Lower Thames Crossing

Thurrock Council Local Impact Report

Appendix C - Transport and Modelling

Appendix C Annex 1 – Technical Summary of Local Junction Impacts

Plate 4-7 Mean Max Queue - 2030

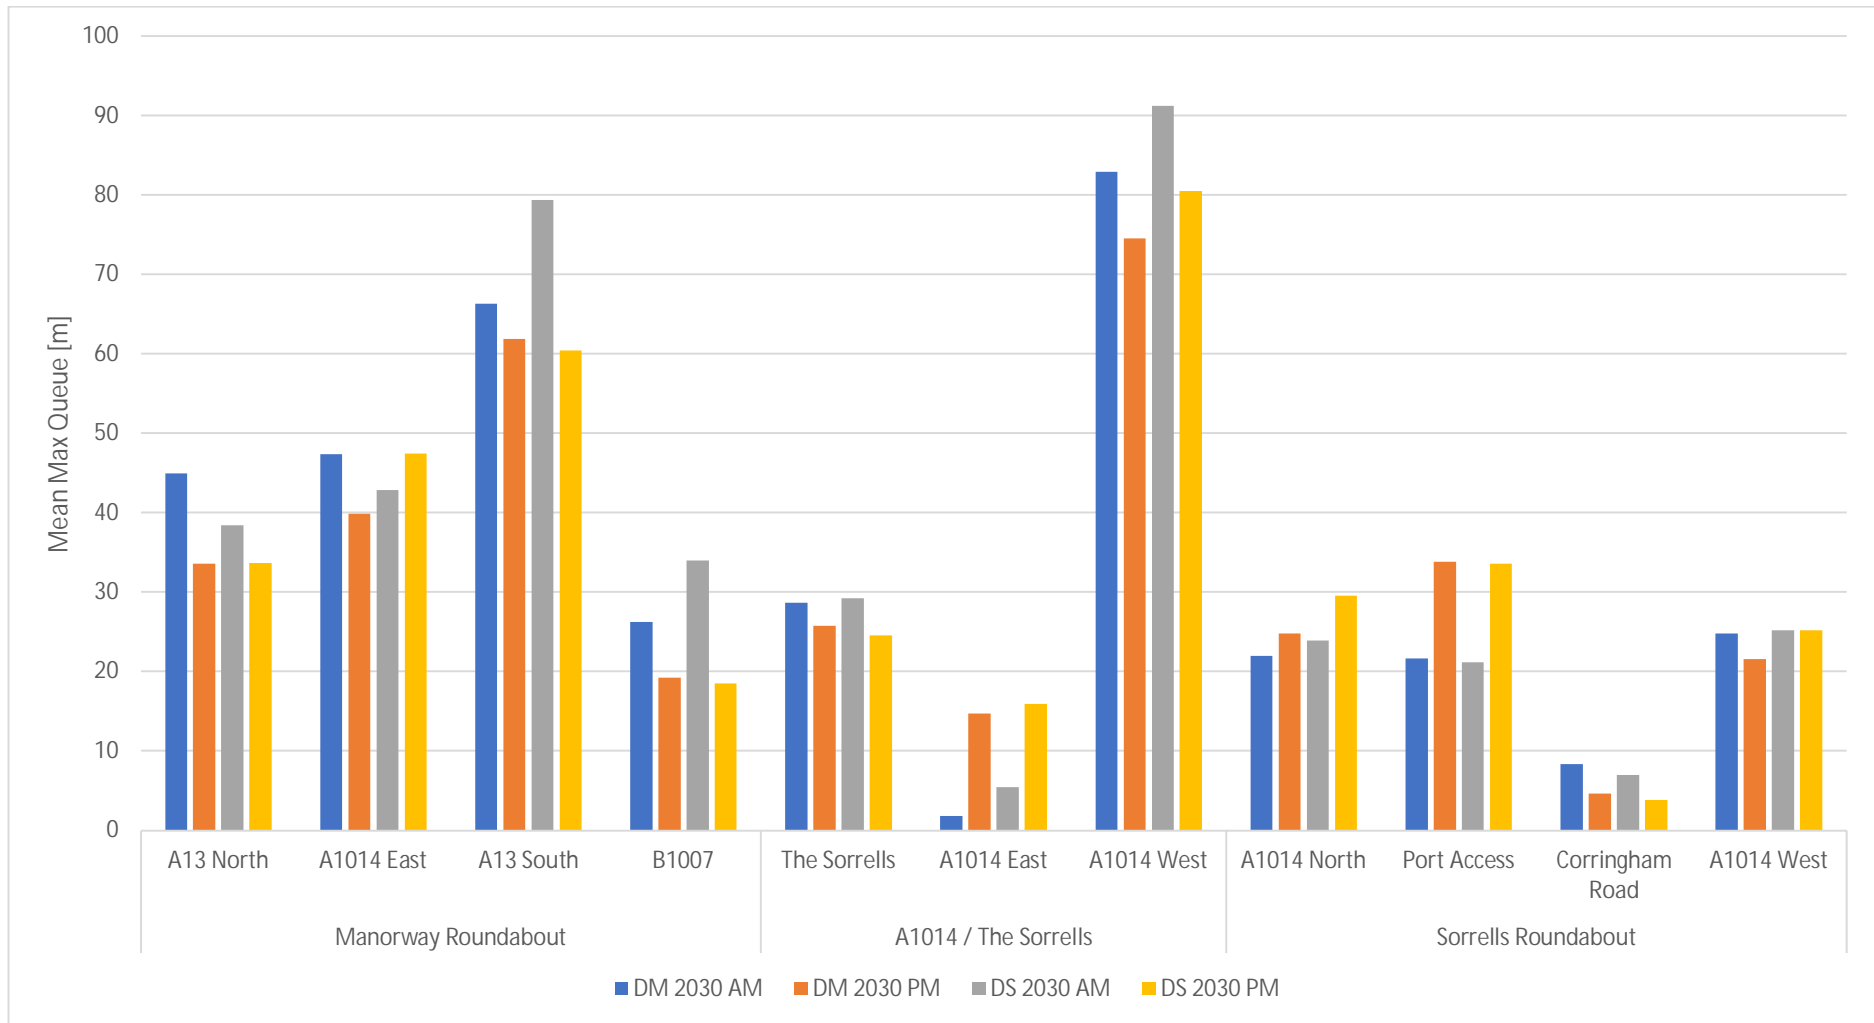
- 4.2.2 Queue counters have been located at the stop lines of each approach in the model. VISSIM considers a vehicle to be in a queue when its speed drops below 5kph and to have left a queue when its speed increases above 10kph and stops measuring the queue when there is a gap of more than 20m between two individual vehicles.
- 4.2.3 The queue length results from the 2030 and 2045 model runs are presented in Plate 4-7 and Plate 4-8 respectively. The graphs show the Mean Max Queue (MMQ) results which is the average of the maximum queue on each approach in 5-minute intervals.
- 4.2.4 The results indicate similar levels of queuing between Do Minimum (without LTC) and Do Something (with LTC) scenarios, with differences of less than four vehicles predicted at each of the individual approaches of all the three modelled junctions.

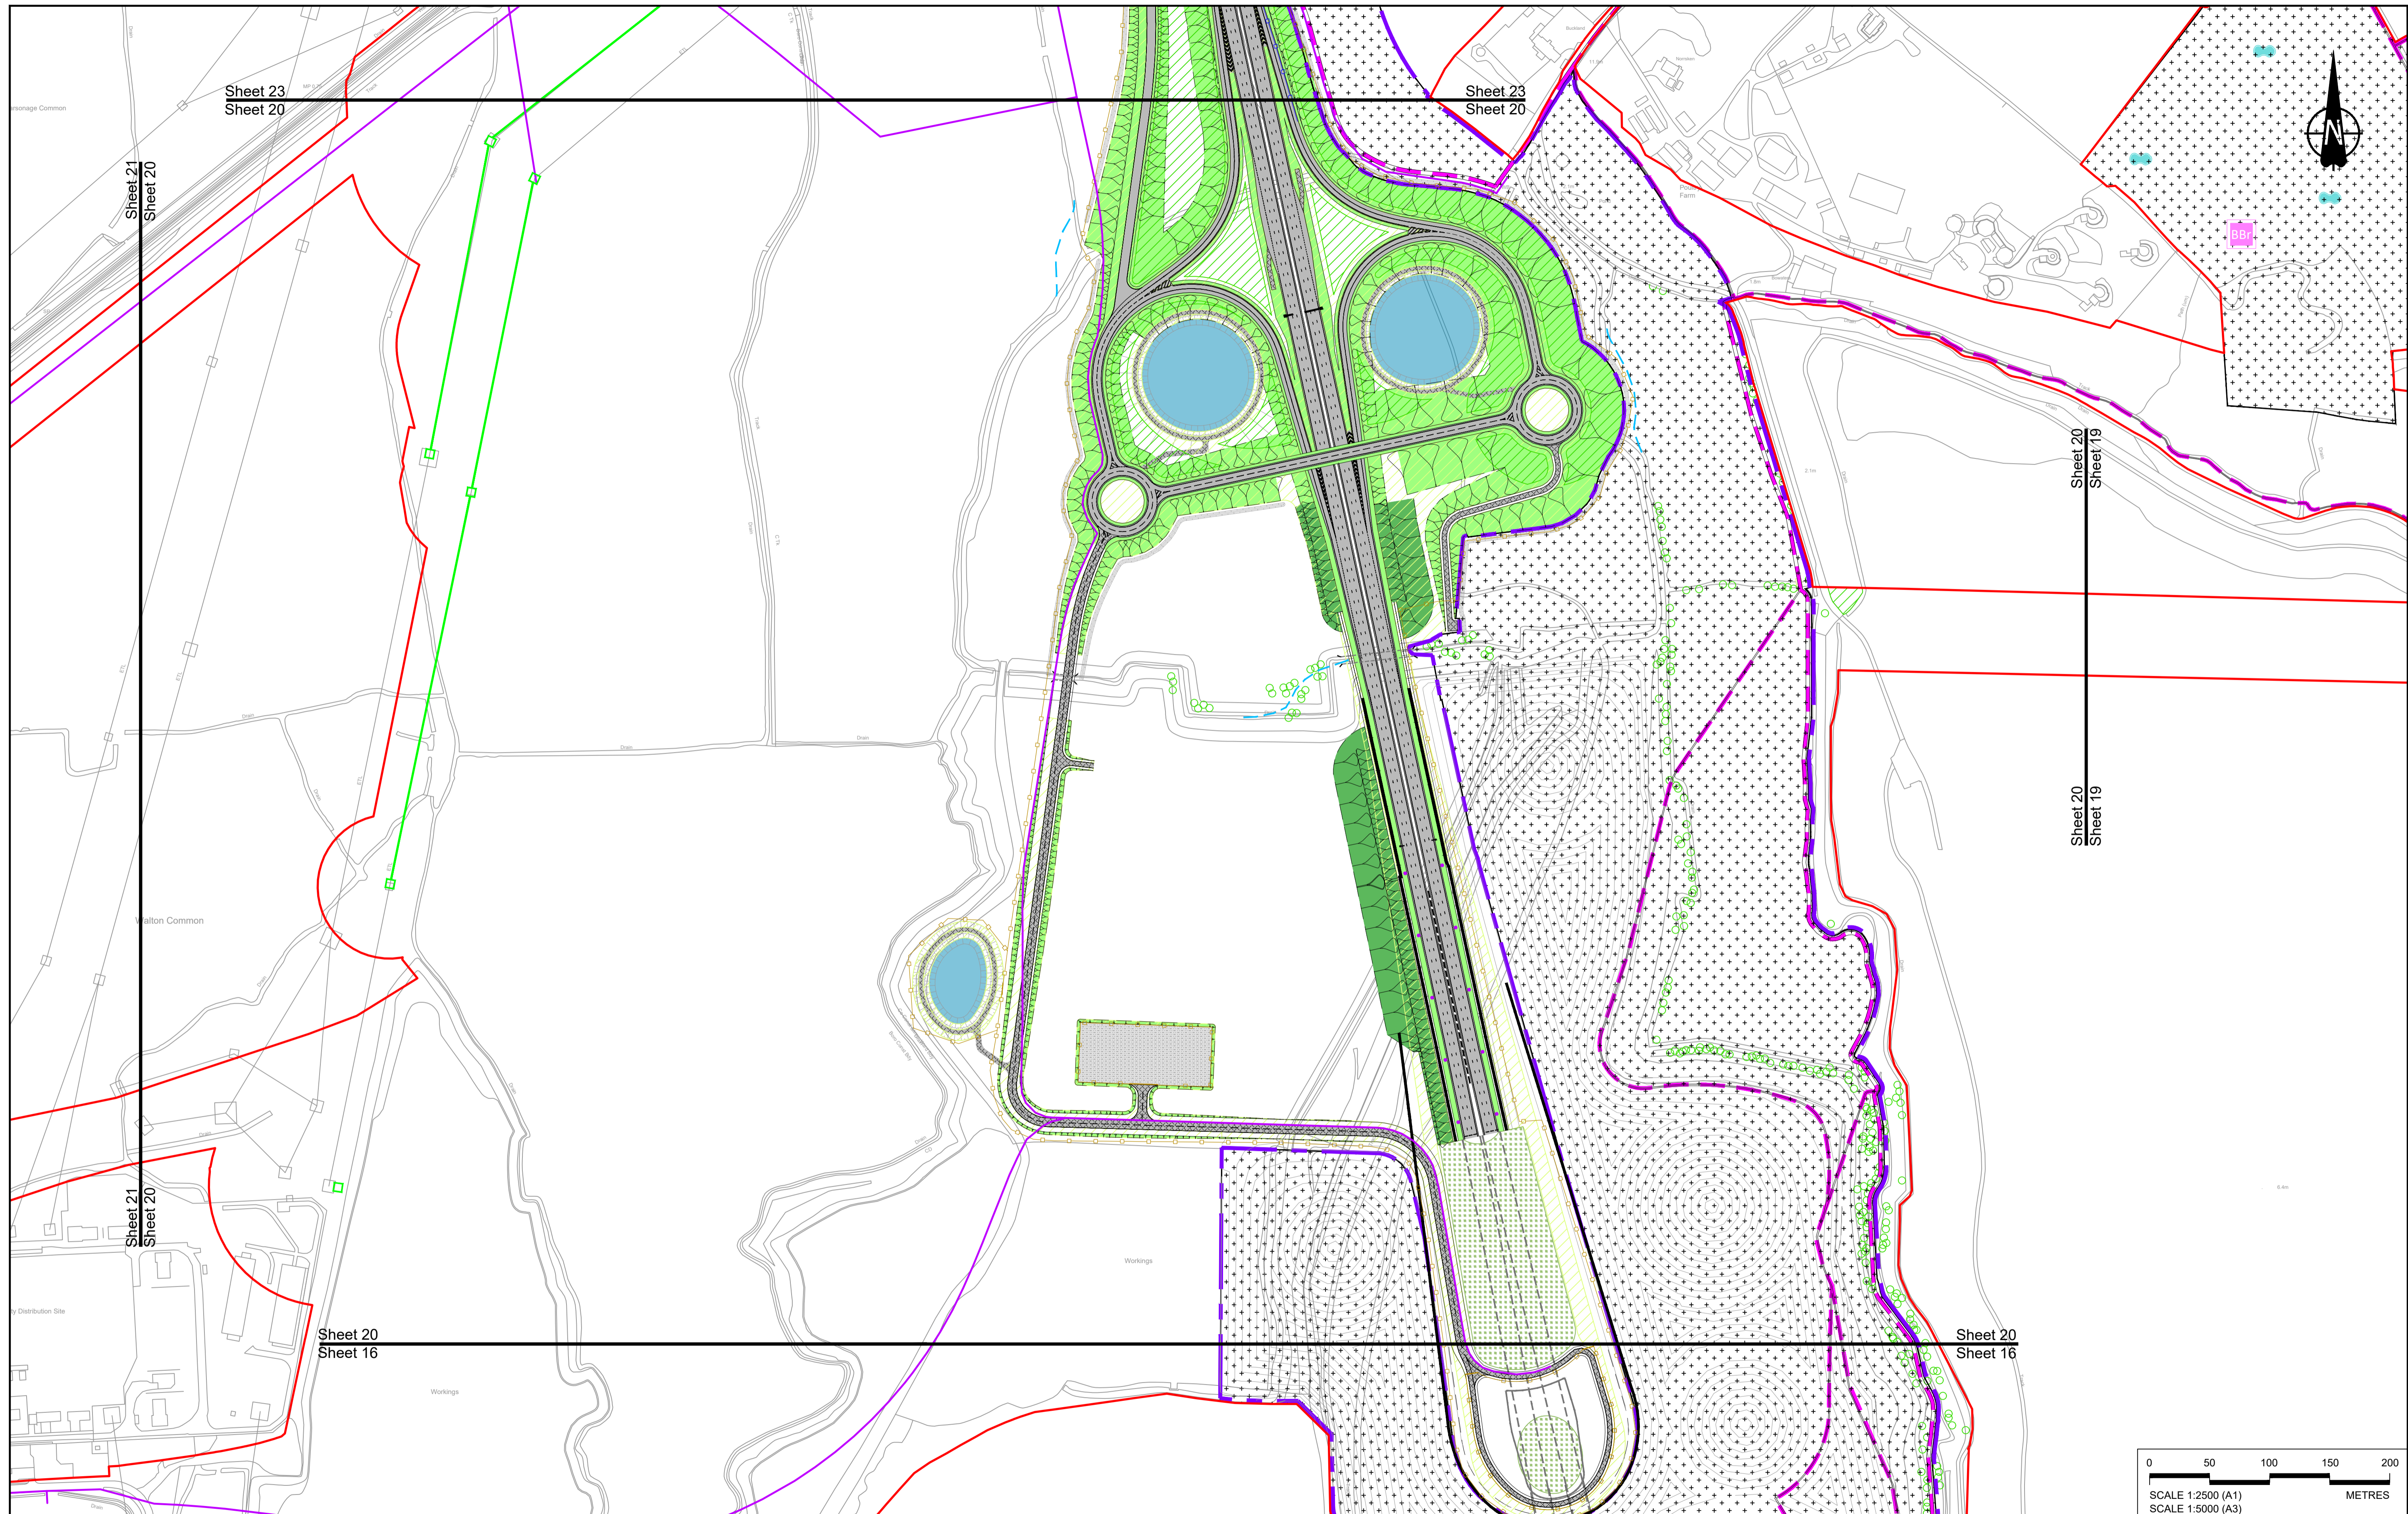
- iii. The proposed NH layout for Tilbury Junction does not include dedicated facilities for public transport or active travel. Space should be provided on the road linking the two roundabouts to provide flexibility to reallocate road space to public transport in the future. Additionally, a combined 5 metre active travel route should be provided on the southern side of the road between the East Tilbury connecting corridor and the Tilbury Link Road.

- 8.6. Alternative junction improvements or configurations could be assessed as part of future studies to determine whether Tilbury Junction could facilitate higher levels of traffic demand from the TLR and East Tilbury.

Figure 7-7 Roads and Areas of Concern

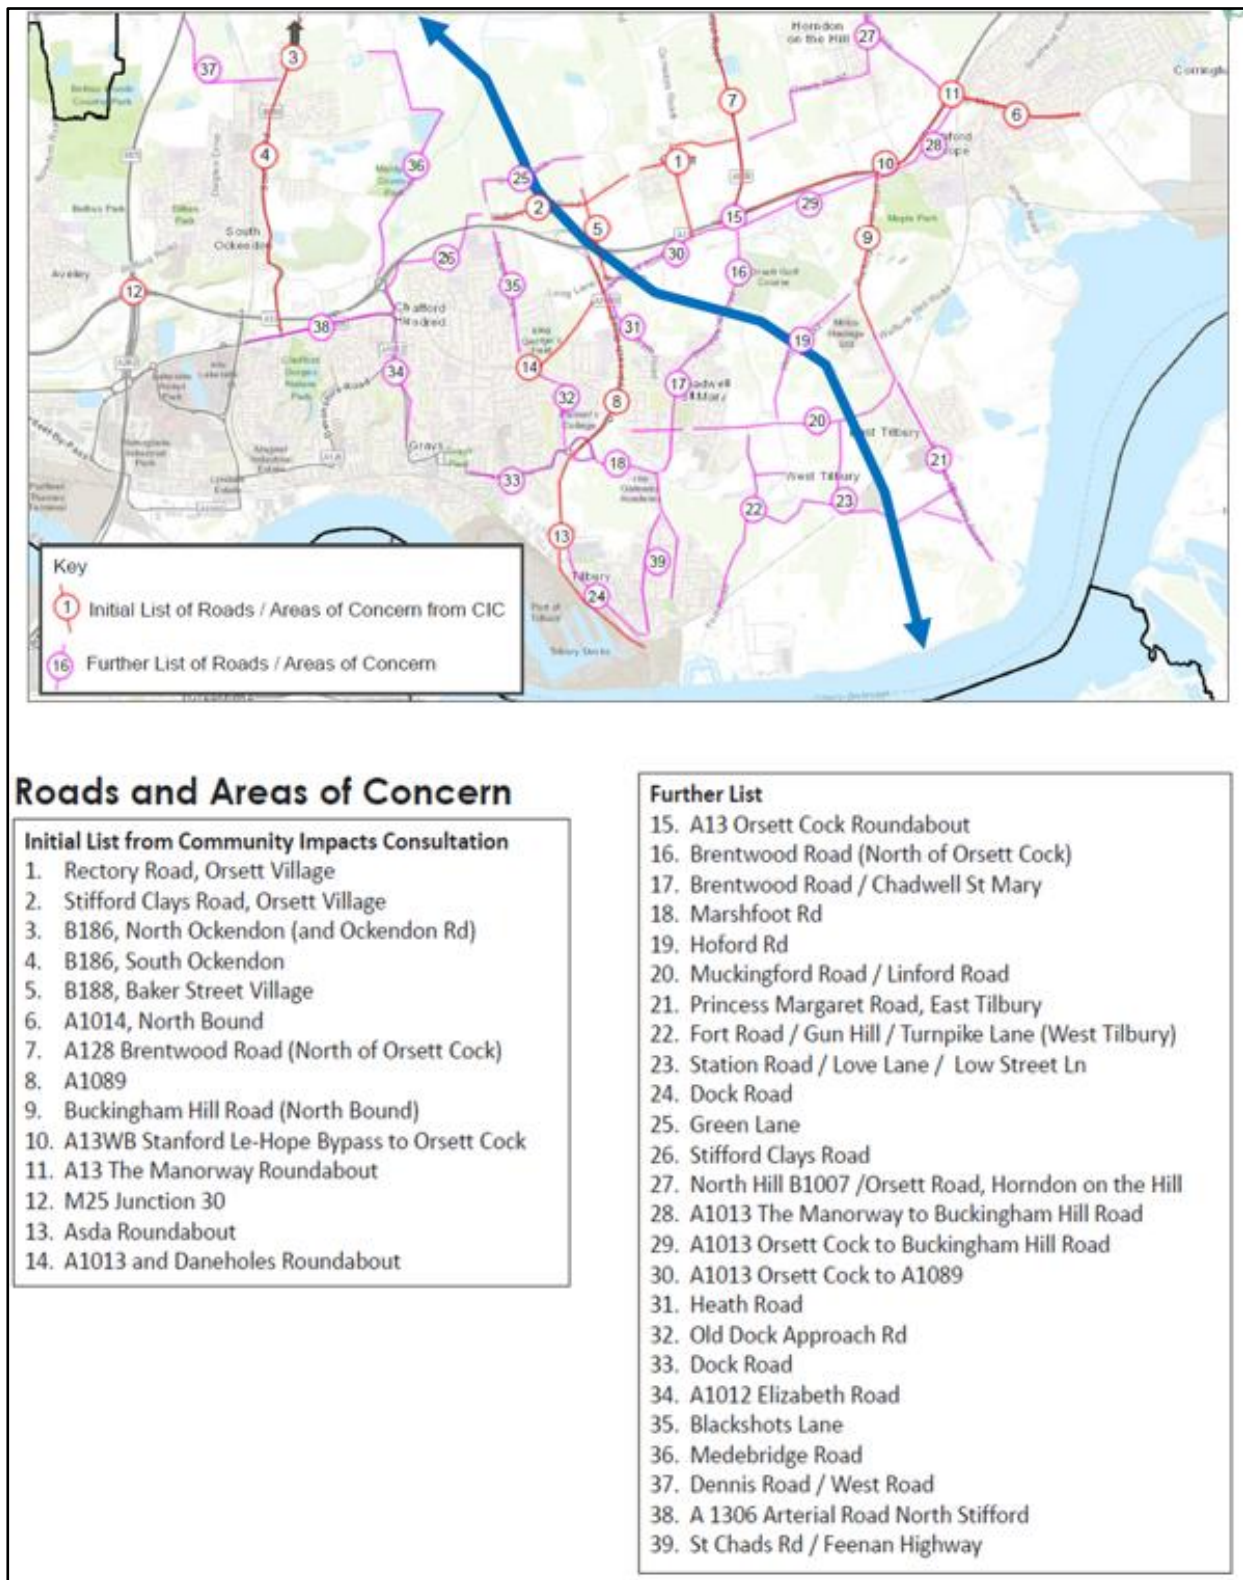
- 7.3.7 It is proposed that impacts on the LRN in Thurrock are monitored and managed during the construction period with appropriate management and mitigation actions taken as needed, promoted through the relevant Traffic Management Forum with NH, the MWCs and TC. This is identified through the governance framework within the OTMPfC. An initial network monitoring plan for the LTC construction period has been proposed by TC for inclusion in the OTMfC and is shown in Figure 7-8. Monitoring during construction will need to be flexible to reflect changes in proposed activity during each construction phase and to address unexpected impacts.
